PHILADELPHIA ELECTRIC COMPANY
NUCLEAR GROUP HEADQUARTERS
955-65 CHESTERBROOK BLVD.
WAYNE, PA 19087-5691
(215) 640-6000

SUBJECT: Peach Bottom Atomic Power Station, Units 2 and 3
Clarification of Second Interval ISI Program
Relief Request

Summary of Changes to PBAPS 2 and 3 ISI Relief Requests

PEACH BOTTOM
TYPICAL MANUAL UT ACCESSIBILITY

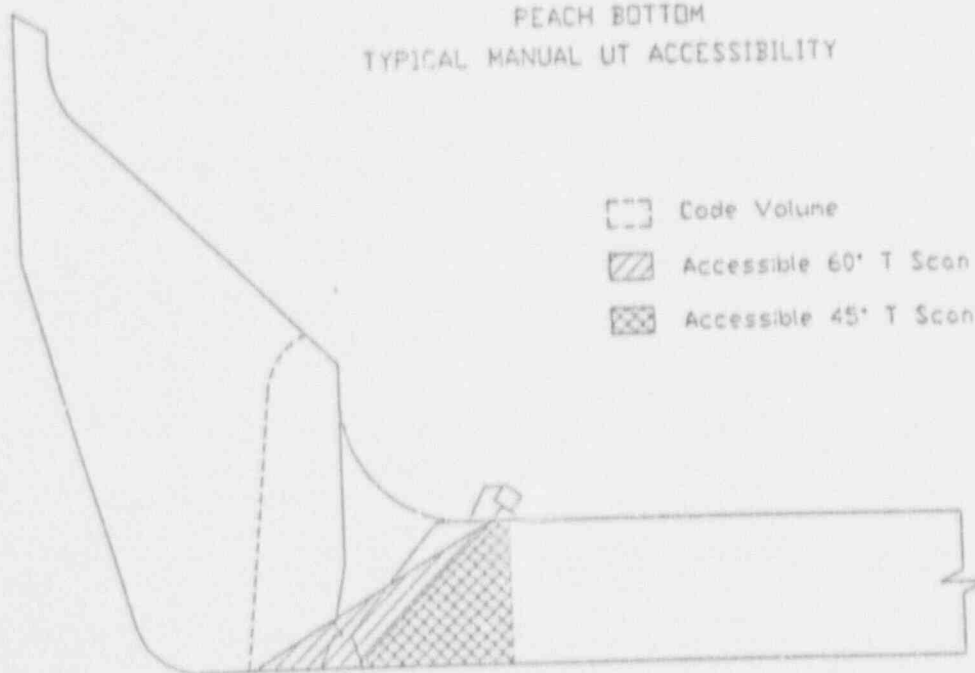
- a) Why are the examination coverages small relative to the Code required examination volume?
- b) Why is the 45 degree parallel scan impractical?
- c) Why is a better examination coverage achieved with the 60 degree transverse scan versus the 45 degree transverse scan?

Provide a diagram which will support the request for relief from performing complete examinations.

a) Overall examination coverages are low due to the barrel type nozzle configuration which restricts the examination scanning to one side of the weld. The one sided examination is further limited by interferences of the scanning equipment with nearby components.

b) The 45 degree parallel scan is impractical because skewing of the 45 degree transducer (to examine the subject weld metal at the nozzle inside surface) during the parallel scan would cause the sound beam to be directed nearly perpendicular (transverse) to the weld centerline. This would render the examination ineffective as a parallel scan.

c) Since examination is only possible from one side of the weld, the 60 degree transverse beam will scan the largest

portion of the Code required volume, as depicted in the drawing on Attachment 1.

Attachment 2 contains a sketch of this pump support configuration.

As an additional update to this relief request, the extent of examinations completed has been reduced from 50% to 20%. This reduction in coverage is the result of a plant modification which added reinforcing plates to the original pump support structure. These reinforcing plates cause three of the four reinforcing rib attachment welds to be inaccessible for surface examination.
